Software Release **WBX.4721** Details

Software Version: *WBX.4721*

Applies to Products:

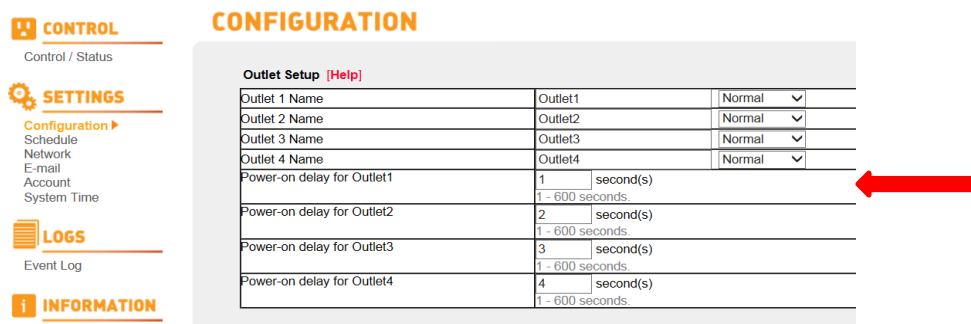
- **Website / IP Address Name Column**
A custom name may now be set for websites or IP addresses being pinged.
